MIL-F-70807 (AR)
AMENDMENT 3
23 February 1990
SUPERSEDING
AMENDMENT 2
19 October 1988

FUZE, PD: M745
(LESS BOOSTER AND LEAD)

FIGURE 1

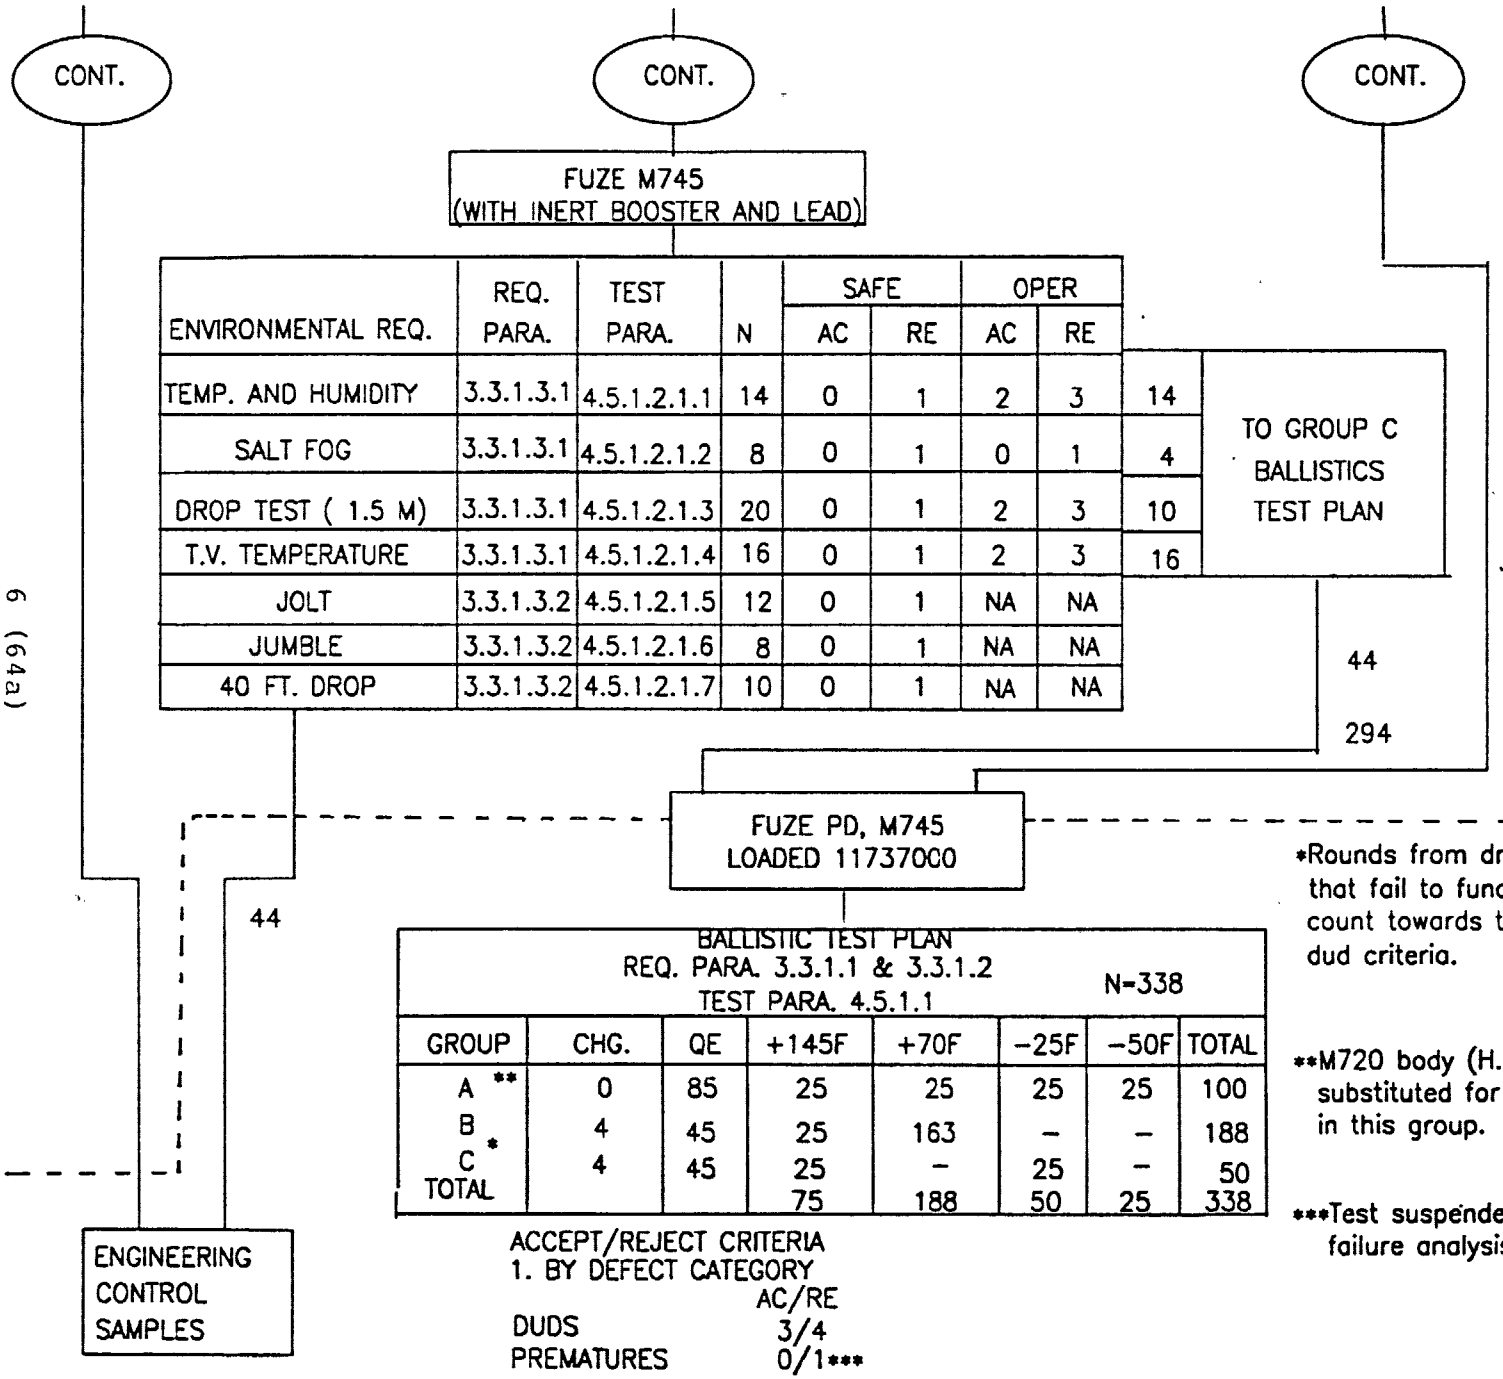
3.1.1: Change "458" to read "436," and change "428" to read "406."

* Delete in its entirety and substitute included pages 64 and 64a.

FIGURE 2

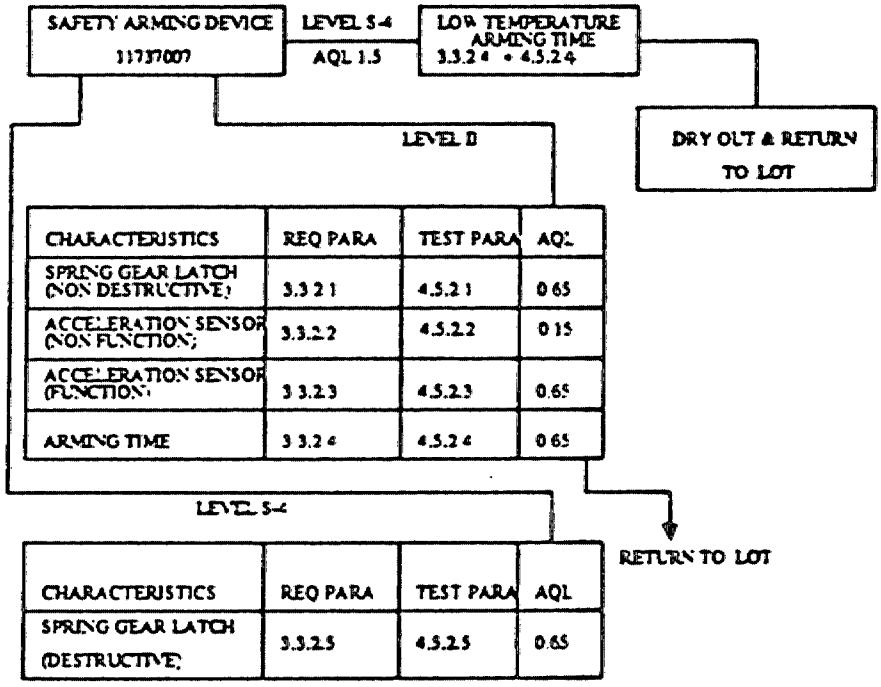
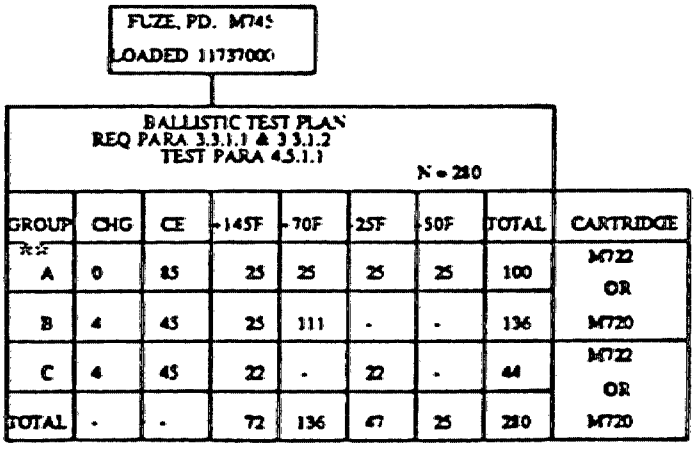
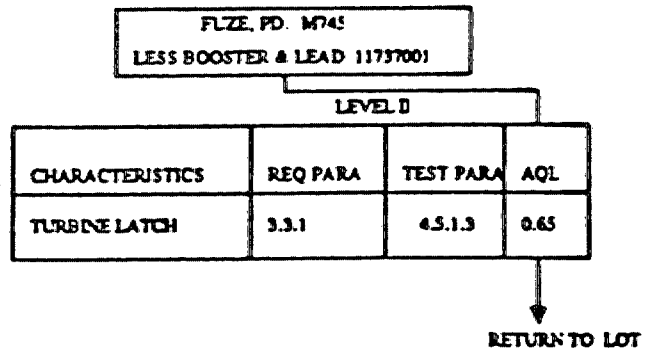
3.1.4.1 Initial production lot. Select at random ballistic lot acceptance samples from first production lot. Ballistic lot acceptance test plan is shown in figure 2.

* Delete in its entirety and substitute per included sheet.

FIGURE 3

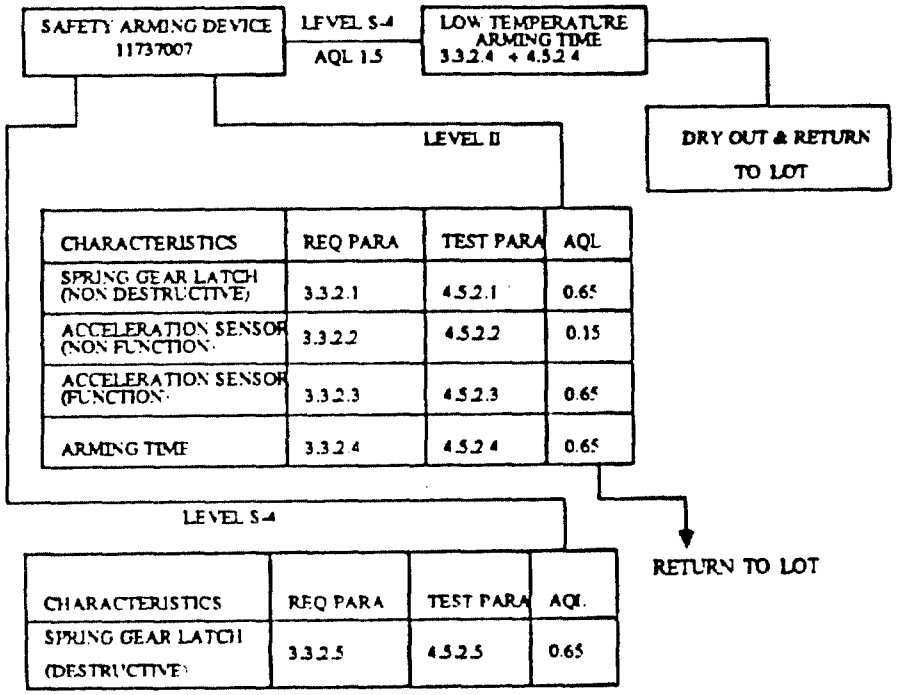
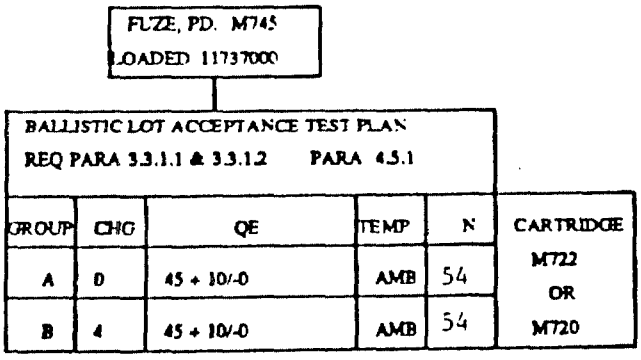
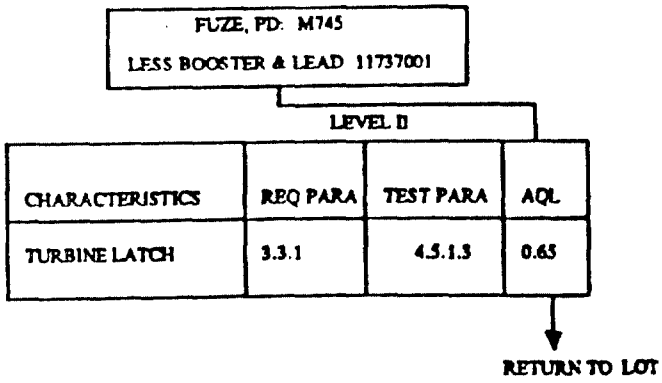
3.1.4.2 Production lot. Select at random ballistic lot acceptance samples from each production lot. Ballistic lot acceptance test plan is shown in figure 3."

Delete in its entirety and substitute per included sheet.

FIGURE 4 INTERFACE CONTROL DRAWING

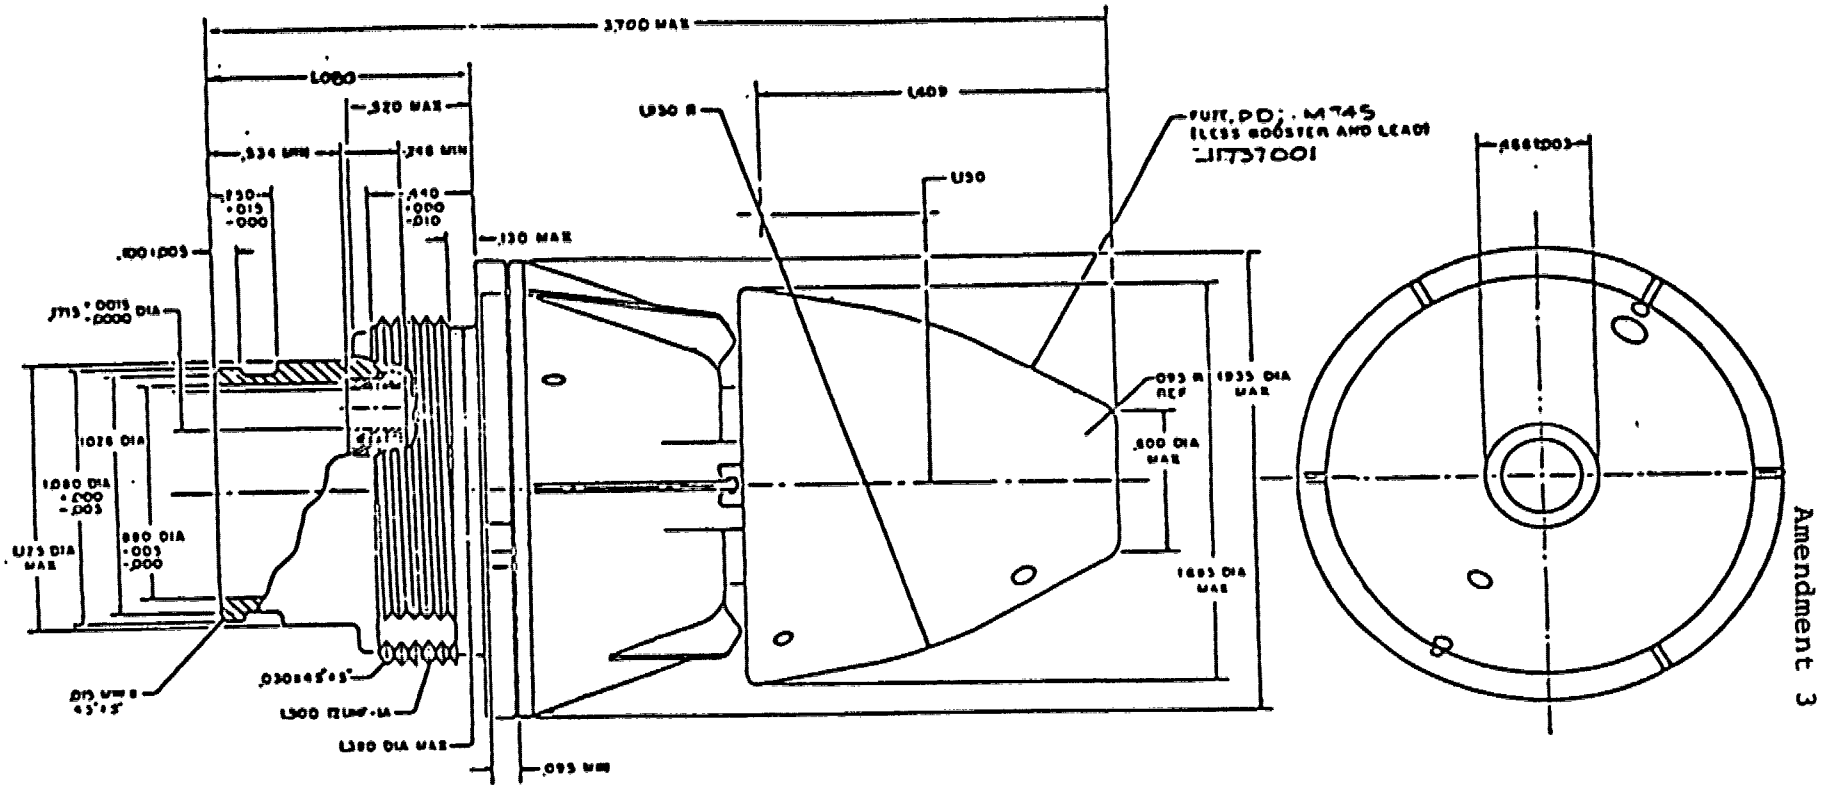
3.2: Change "(Figure 3)" to read "(Figure 4)."

Figure 4: Add new figure per included sheet.
